NAC INTERNATIONAL

REQUEST FOR ADDITIONAL INFORMATION

NAC UNIVERSAL TRANSPORT SYSTEM (NAC-UMS®)

SAR SUBMITTAL – REVISION UMST-01D

Figure RAI 2.9-1 Dynamic Load Factor for Single Degree of Freedom System – Triangular Pulse Shape, No Damping

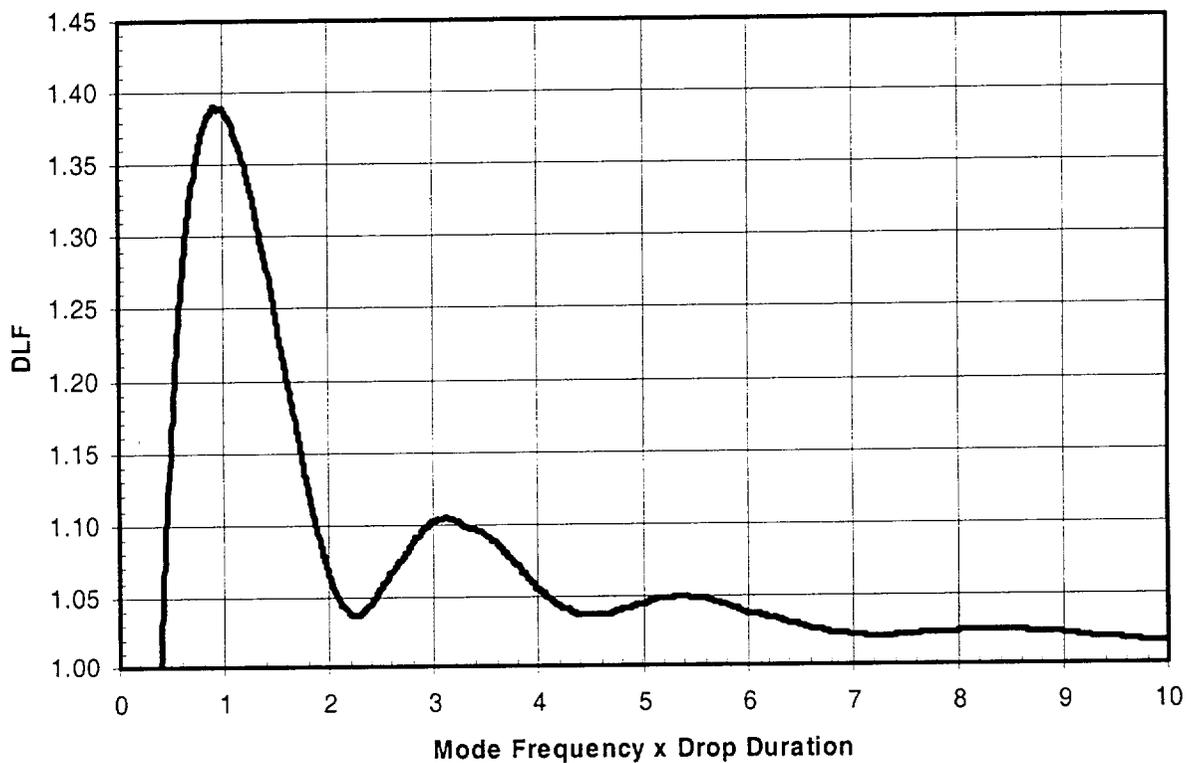
2-9 With respect to SAR Figures 2.6.7.5-5, -6, and -7, provide an evaluation of effects of vibratory response components on the maximum decelerations as presented in Table 2.6.7.5-6.

To determine the predominant cask vibration modes of interest, a modal analysis of the basket support disks was performed using the ANSYS program that calculates the frequencies for the side drop for the BWR and PWR baskets for the end drops and side drops. To determine the dynamic load factor (DLF), the side drop and end drop are treated as single degree of freedom systems with triangular pulse shape and no damping. Figure RAI 2.9-1 plots the DLF verses the mode frequency times the drop duration for a triangular pulse shape. The following table summarizes the DLF for each orientation.

In all cases, the factored accelerations that include the effects of the cask vibratory response are less than the design accelerations employed in the evaluation of the UMS[®] cask.

Figure RAI 2.11-1 Comparison of Quarter-Scale Model Side Drop (LS-DYNA and Drop Test) Results (Upper Accelerometer)

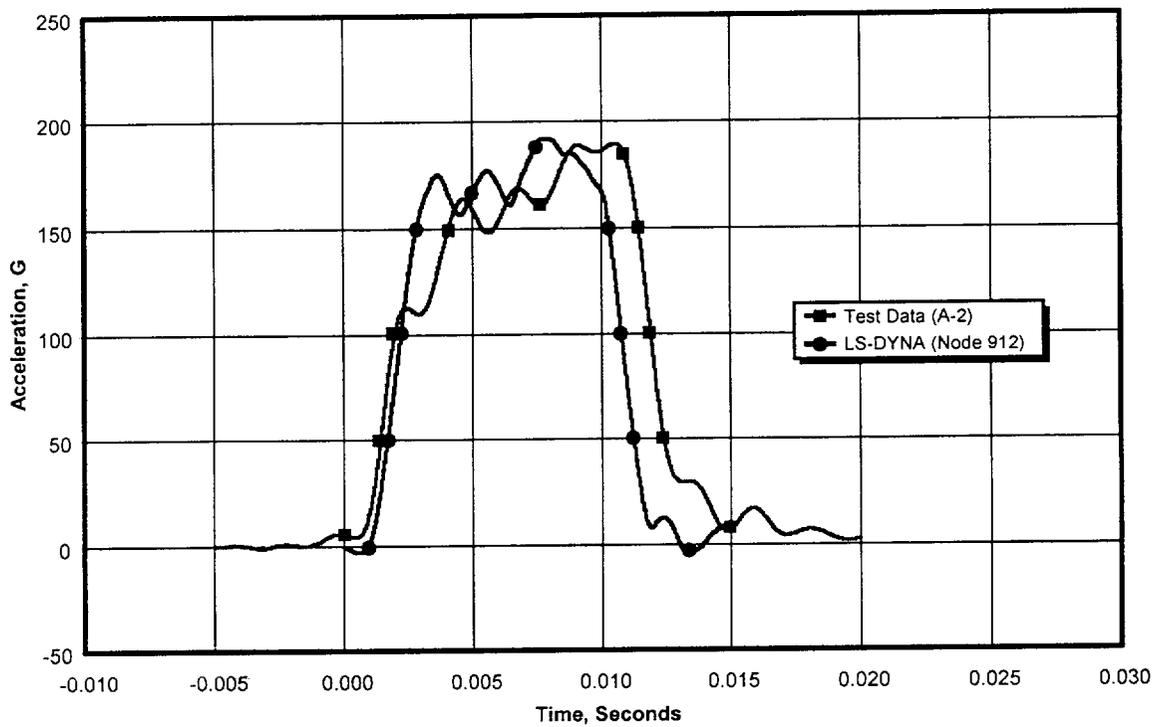
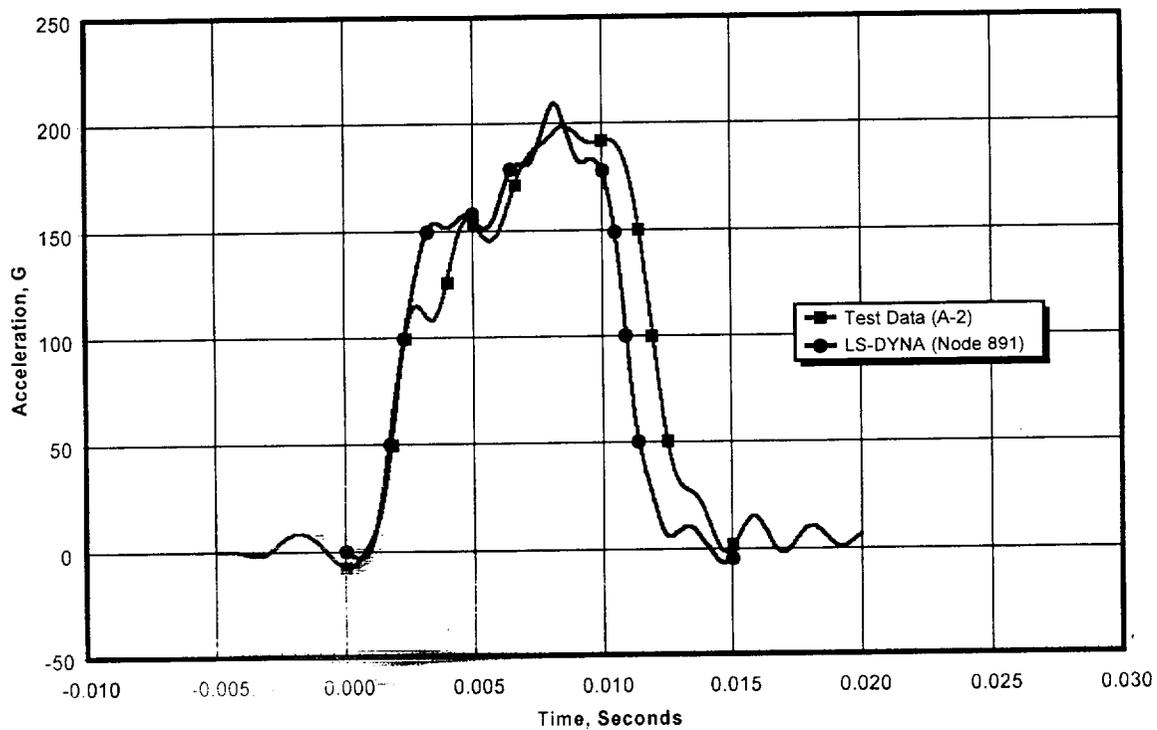
- 2-11 With respect to Figures 2.10.3-8 and -9, explain why the LS-DYNA calculated and low-pass filtered deceleration time histories do not contain similar vibratory response components to those recorded for the side drop test.

The staff notes that both the analysis and test raw data were reduced with the same low-pass filtering parameters. As such, the analysis results are expected to display also the vibratory response components superimposed on the rigid body cask responses. Complete and accurate information should be provided, per Section 71.1(a), for evaluating the package free-drop performance under Sections 71.71(c)(7) and 71.73(c)(1).

The vibratory response noted in the test data is a direct result of the sampling rate at which the data was recorded. The sampling rate used by Sandia National Laboratories during the quarter-scale model side drop test was approximately 250,000 Hz, which results in a data point being recorded every 1/250,000 seconds and reduces the effectiveness of the Butterworth filter. Typical LS-DYNA analyses are performed with sampling rates from 50,000 to 100,000 Hz. For the purposes of this evaluation, the data rate in LS-DYNA was increased to 250,000 Hz. Figures RAI 2.11-1 and RAI 2.11-2 provide the comparison of the analysis and test data with the 250,000 Hz sampling rate. Both curves are filtered at 450 Hz. Figures 2.10.3-8 and -9 have been updated with the new results. The updated curves show similar frequency content in terms of the oscillatory behavior.
